Construction Traffic Management Plan

The Bays – Stage 1 – Site Establishment Rev 01

Project number	7040
Document number	SMWSTETP-JCG-SWD-SN000-TF-PLN-002049

REVIEW COMMENTS SHEET

Appendix E Swept Path Assessment

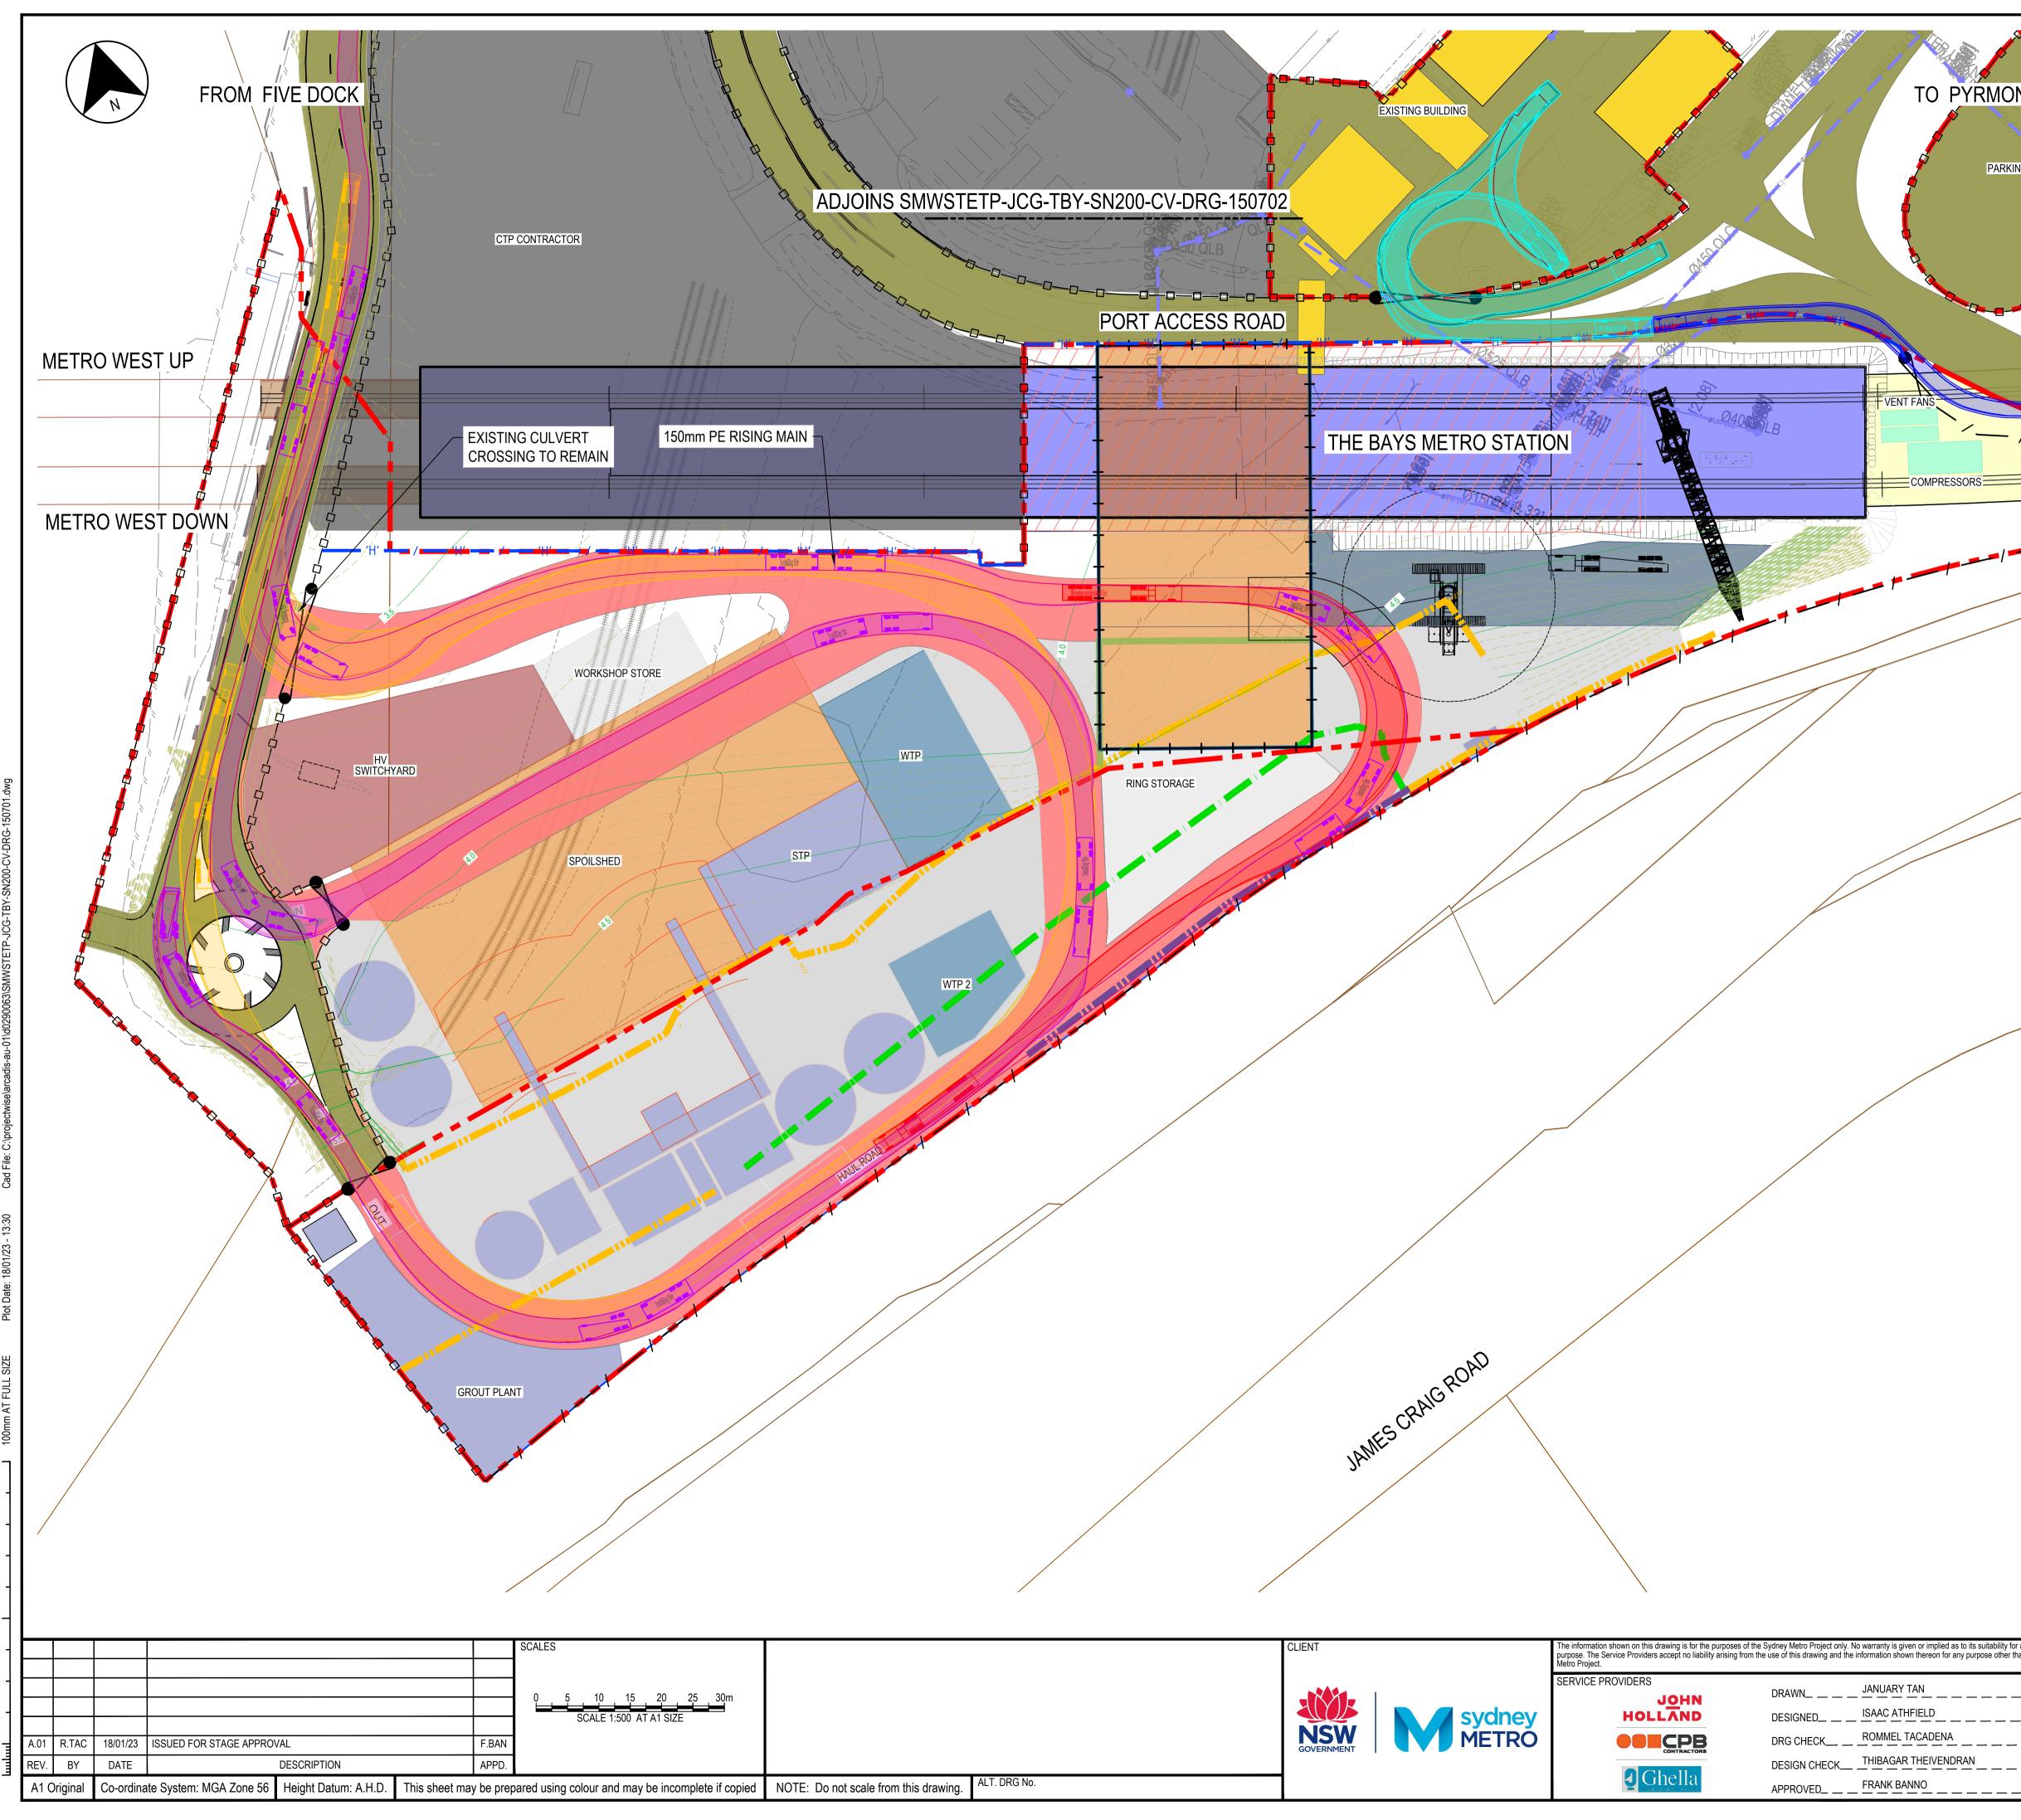
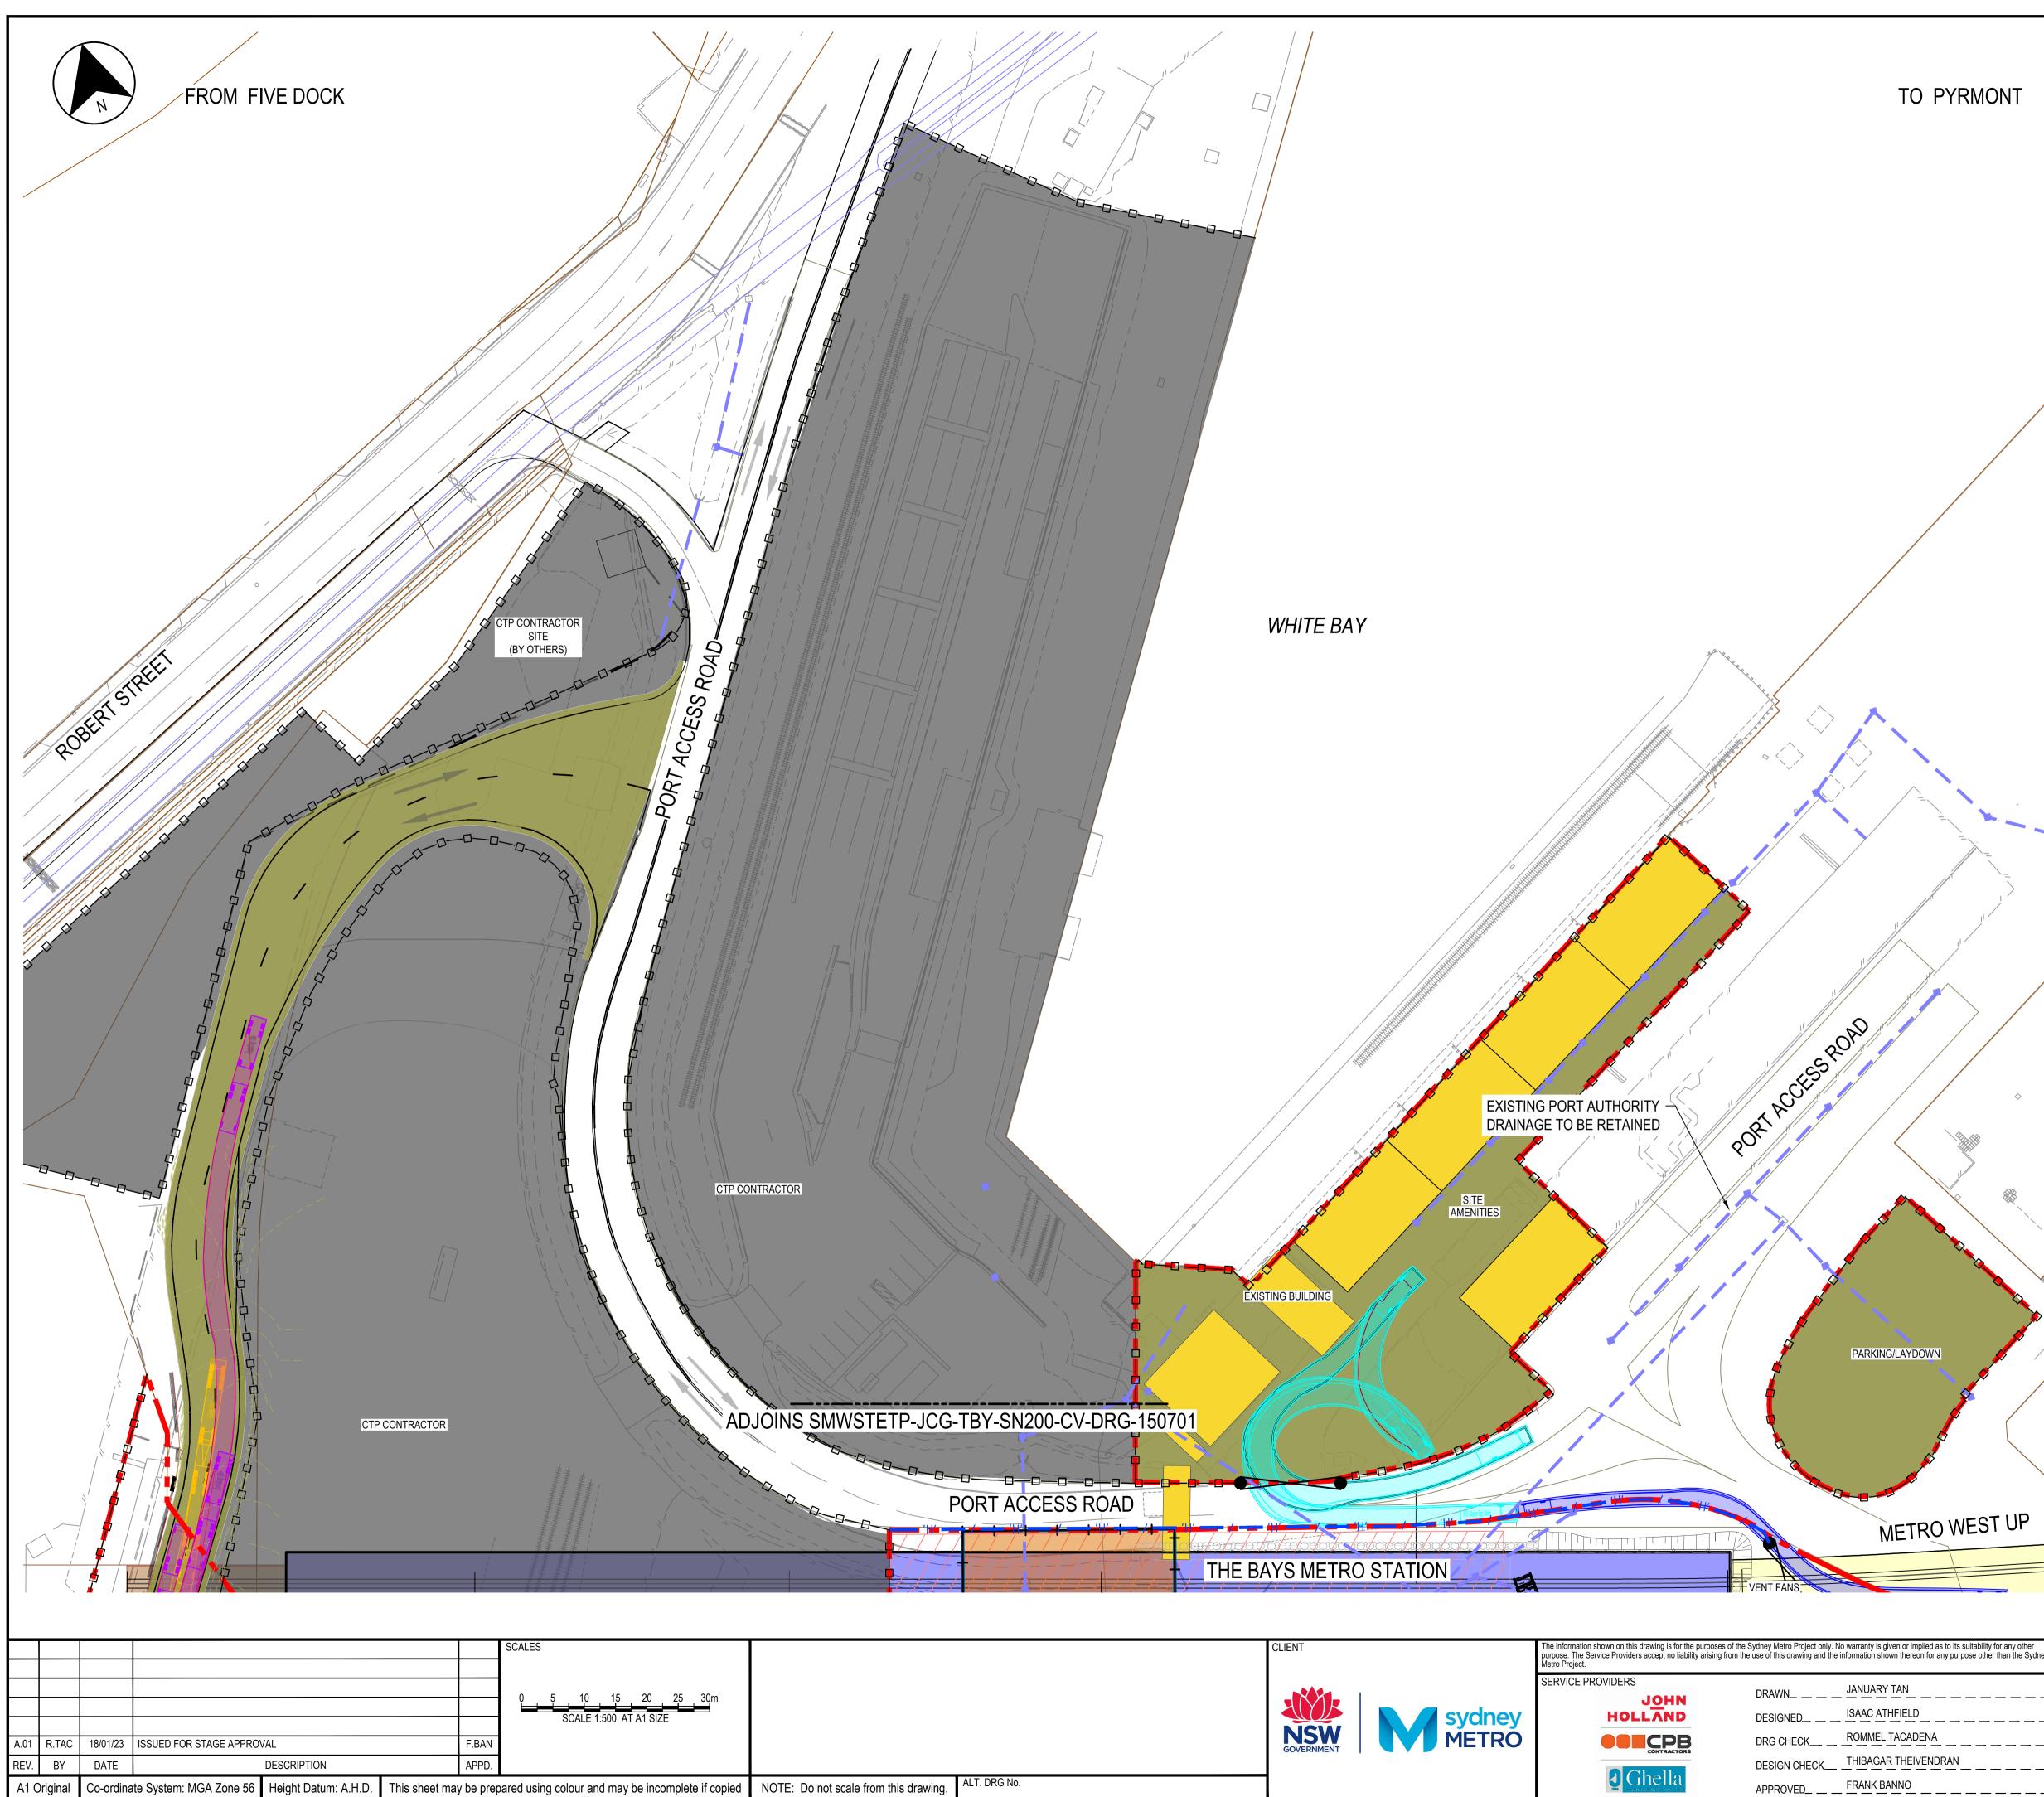
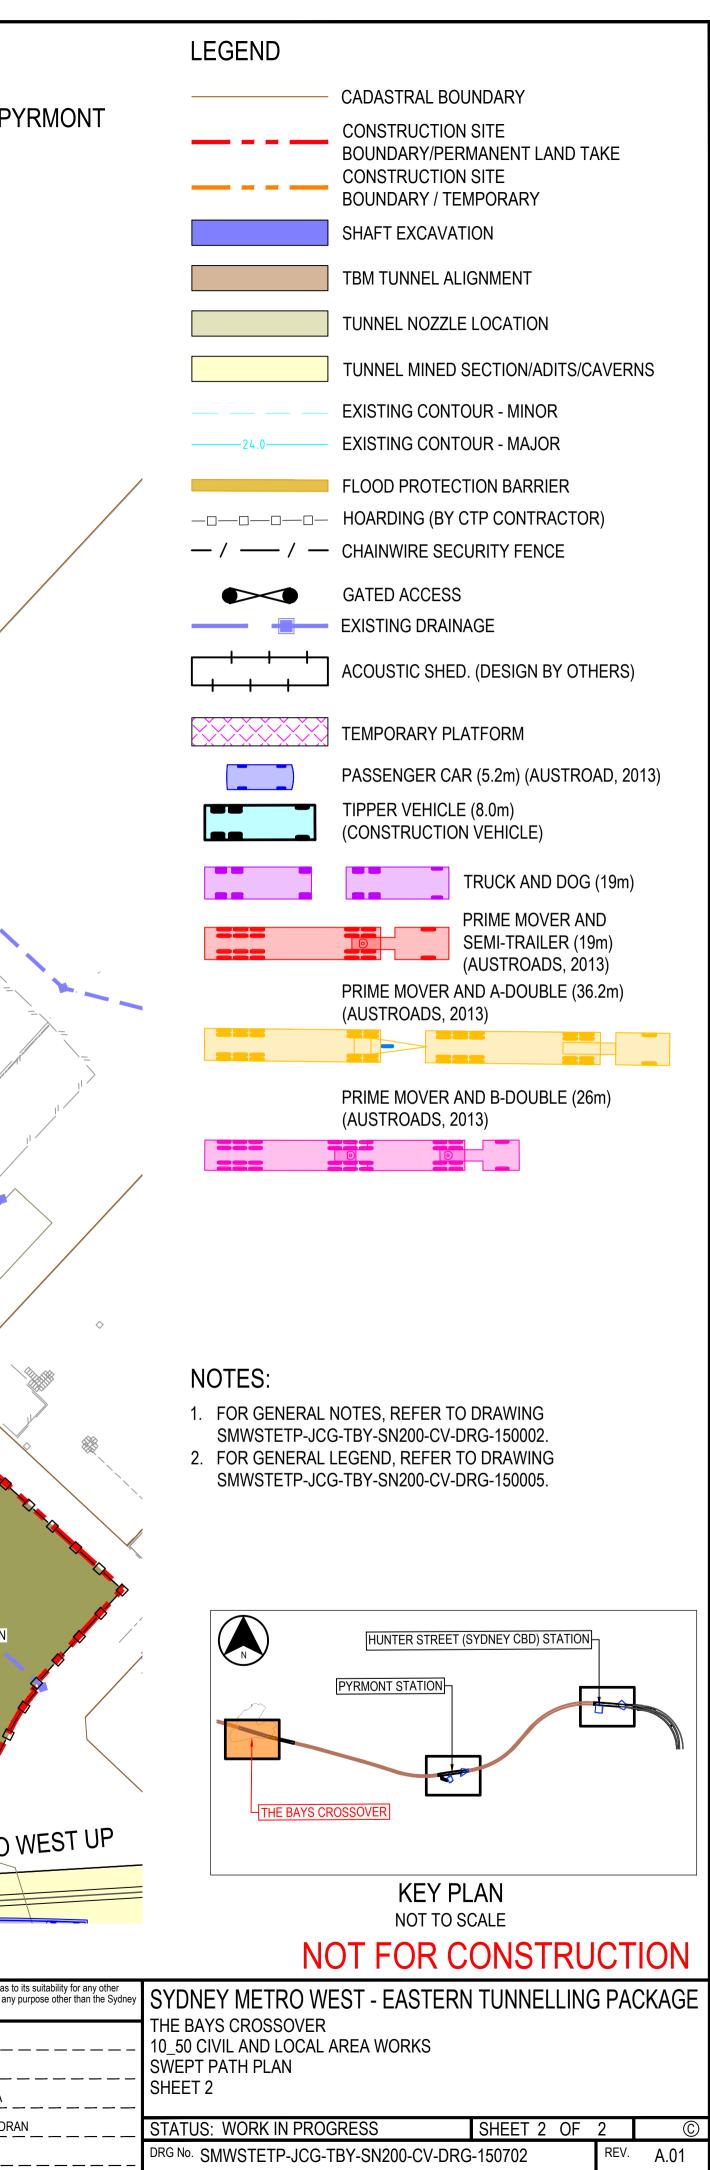
SMWSTETP-JCG- SWD-SN000-PM-PLN 002049	Section 7.10	NA	Section 6.10 (formerly 7.1) updated to address the comment	Observation	Ν
				33	20/02/2023	RMS	HYOUSAF	SMWSTETP-JCG- SWD-SN000-PM-PLN 002049	Appendix E	NA	Use the updated drawing in Appendix E based on the comments from RSA.	Observation	Ν
								SMWSTETP-JCG- SWD-SN000-PM-PLN 002049	Appendix E	NA	Appendix E updated	Observation	Ν
				34	22/02/2023	SMD	SCLARKE	SMWSTETP-JCG- SWD-SN000-PM-PLN 002049	Section 4.4.2	N/A	The heading should be Traffic "Control" Group aligning with the first sentence of the section	Observation	Ν
								SMWSTETP-JCG- SWD-SN000-PM-PLN 002049	Section 4.4.2	N/A	Section 4 has been removed from this CTMP to avoid repetition the OCTMP	Observation	Ν
				35	22/02/2023	SMD	SCLARKE	SMWSTETP-JCG- SWD-SN000-PM-PLN 002049	Table 9	N/A	Table 9 identifies HRV as 12m where Table 1 has HRV as 12.5m Update consistency (12.5m)	Observation	Ν

51	23/02/2023	PAN	GJOHNSON	SMWSTETP-JCG- SWD-SN000-PM-PLN 002049	Appendix E	NA	Signage should not clash with other Port Authority / Contractor signage	Observation	Ν
								SMWSTETP-JCG- SWD-SN000-PM-PLN 002049	Appendix E	NA	Noted and comments added to Appendix E	Observation	Ν
